**SUBDIVISION
PLANNED UNIT DEVELOPMENT,
ZONING AMENDMENT,
& SIDEWALK WAIVER STAFF REPORT****Date: October 19, 2017****NAME**

Coast Safe & Lock Subdivision

451 & 457 Dauphin Island Parkway, 1965 & 1967 Antoine Street and 1968 Duncan Street
(Southeast corner of Dauphin Island Parkway and Antoine Street, extending to the North side of Duncan Street, 150'± East of Dauphin Island Parkway)

SITE PLAN

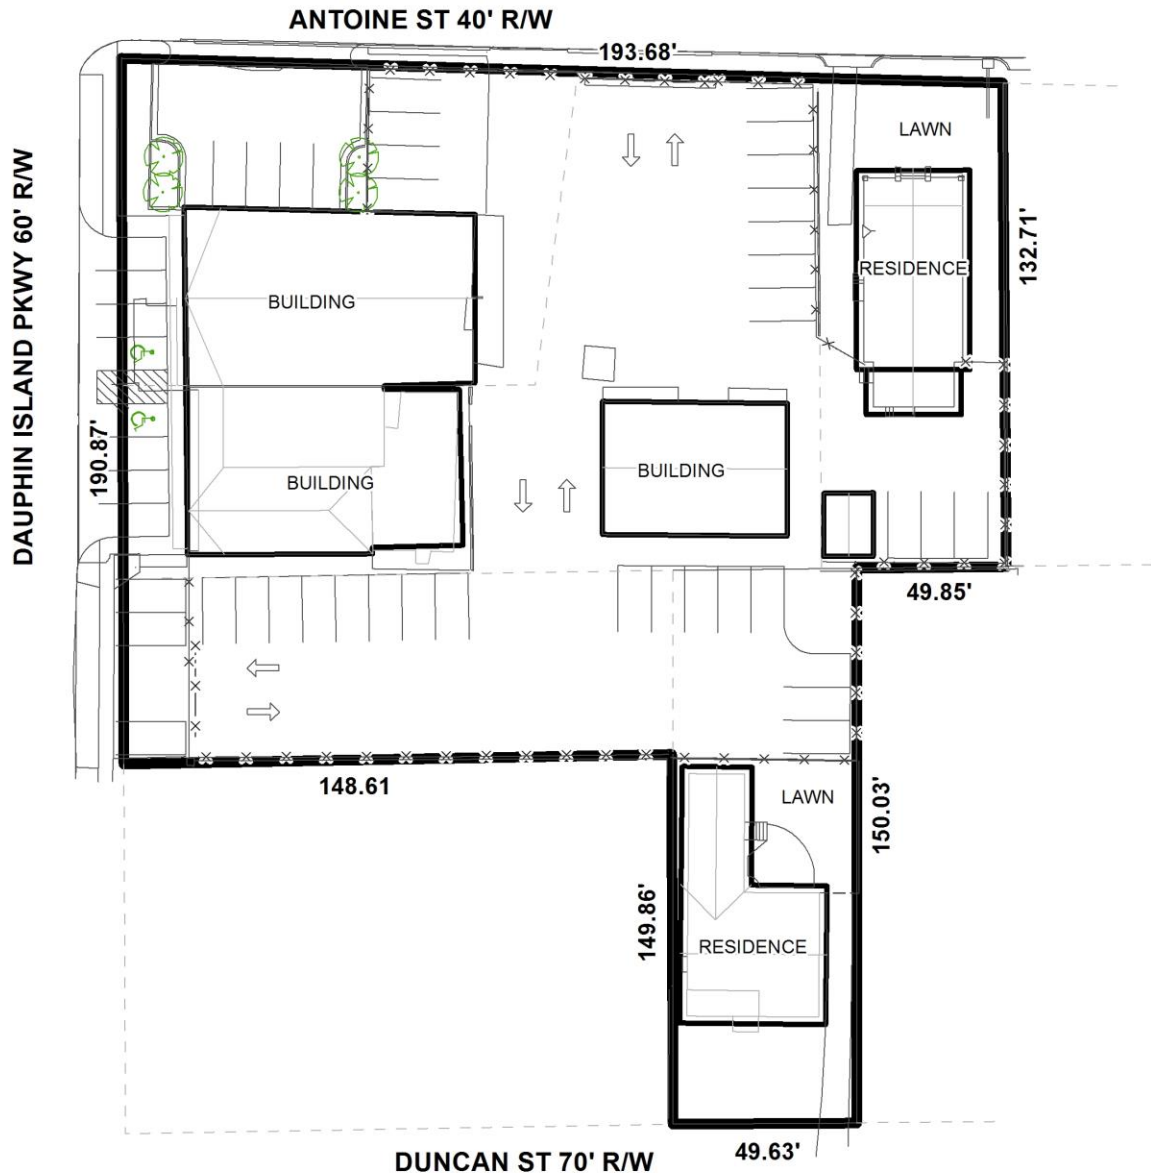
It appears that there is sufficient room within the ROW, or within the property, for the construction of a sidewalk that could be approved through the ROW Permit process. The PUD site plan also indicates some existing sidewalk within the ROW. The Owner's engineer should coordinate with the ENG Department prior to submitting a Land Disturbance or ROW permit. The City Engineer may waive the requirement if an adequate path cannot be located.

The site of the former building is proposed to be paved and converted into five (5) parking spaces, and provided with four (4) understory trees. Overall, the site is proposed to have 46 parking spaces (up to 30 appear to be required), of which at least eleven (11) are partially within the Dauphin Island Parkway right-of-way (and will require backing into the right-of-way), and the remainder of the spaces within the PUD site will be on aggregate surfacing. It appears that nine (9) of the overall spaces are located on the residential properties.

It should be noted that nearly all of the work appears complete, with the exception of the five (5) proposed parking spaces and associated trees. None of the other improvements to the overall site were permitted, it appears, including the work that occurred in the rights-of-way along Antoine Street and Dauphin Island Parkway (new concrete, creation of a large curb-cut).

Regarding the Subdivision aspect of the request, it appears that the proposed lot has a continuous existing curb-cut to Dauphin Island Parkway, which the applicant proposes to reduce to two large curb-cuts. Along Antoine Street, it appears that there are two existing curb-cuts, one of which was expanded without permits after the previously mentioned building was demolished. Typically a lot of this size would be limited to one curb-cut to each street.

Finally, the applicant is requesting the waiver of the sidewalk requirement for approximately the east 123 feet of the proposed lot along Antoine Street. The applicant states that the 40-foot wide right-of-way of Antoine Street does not provide adequate room for a sidewalk. If dedication were required to provide 25-feet from the centerline and a corner radius, adequate room would be available for a sidewalk. It should be noted, however, that there are no sidewalks along the remainder of Antoine Street.

- 1) Revision of the site plan to depict right-of-way dedication as required in the Subdivision conditions;
- 2) Revision of the site plan to eliminate access and commercial use of the rear of the two residential properties (1965 Antoine Street and 1968 Duncan Street);
- 3) Revision of the site plan to depict full tree and landscaping compliance for the overall site;
- 4) Revision of the site plan to reflect one curb-cut to each street; and
- 5) Revision of the site plan to depict a sidewalk along Antoine Street.
